COMMUNITY DEVELOPMENT
Planning & Zoning Division

SUBJECT: July 28, 2026 HISTORIC PRESERVATION COMMISSION MEETING

STAUNTON HISTORIC PRESERVATION COMMISSION**June 23, 2026****5:30 p.m.****Council Chambers**

HSF Recommendation

Add a 3'x7' balcony to the East facade

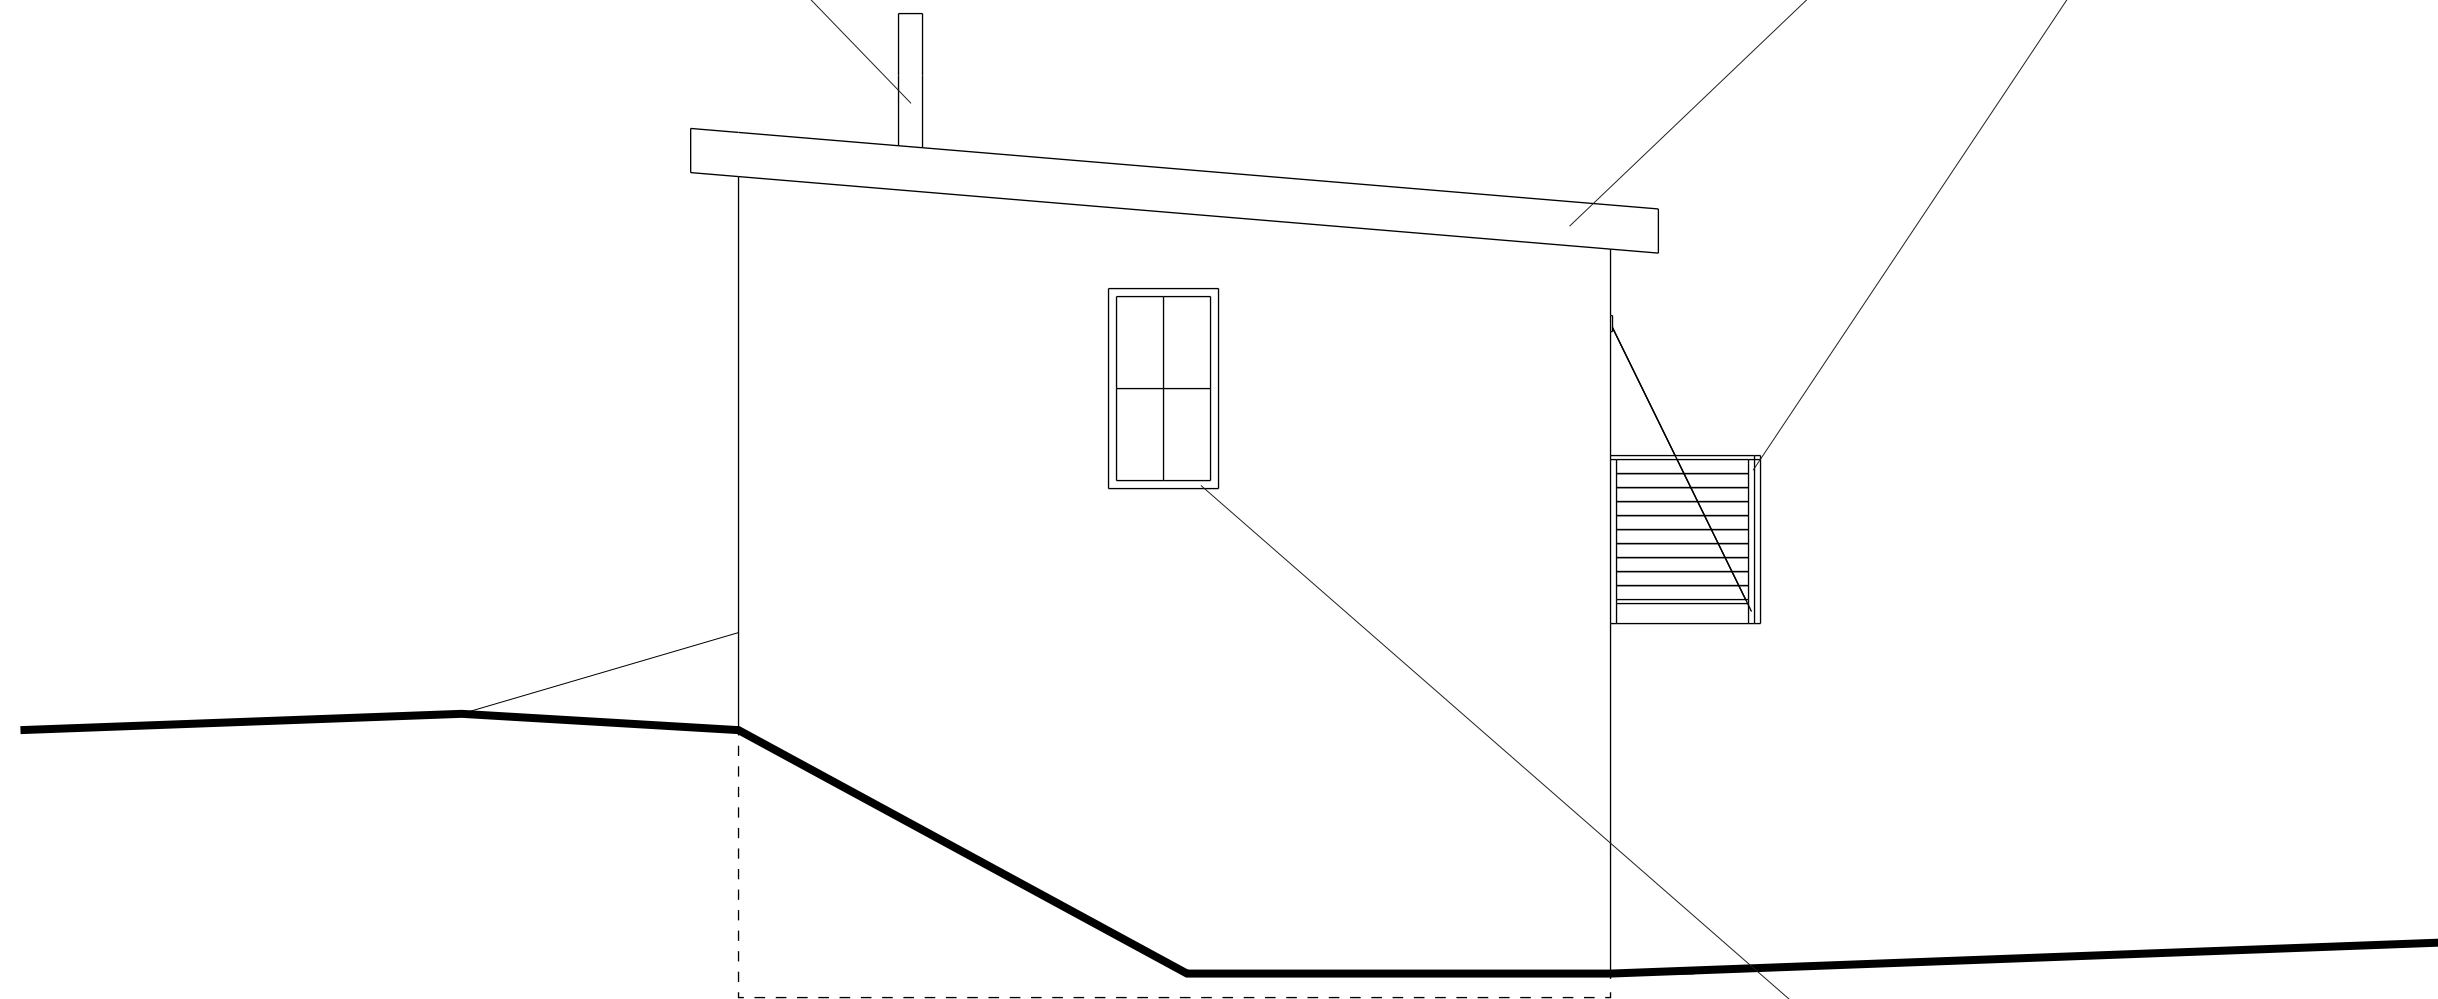
- Add glass panels to the top two rows of the existing garage doors.
- Paint garage doors black
- Add flue pipe for a new interior wood burning stove

- New Openings w/Black Aluminum Clad Windows + Doors
- Add a 3'x7' balcony to the East façade

- Replace the existing window on the South Facade with a new black aluminum clad window

The project involves renovating an existing brick garage. Most of the materials to be used will be existing. The brick will remain as-is. The existing fascia, soffit, garage doors and garage door header will be painted black. Windows and doors will be replaced with new black aluminum clad wood windows. A new steel balcony will added.

The rail and style construction with panels allow a retrofit of the upper panels with glass lights, reflecting the character of early 20th Century garage doors. Therefore, the change alters an existing replacement door by adding compatible glass panels.
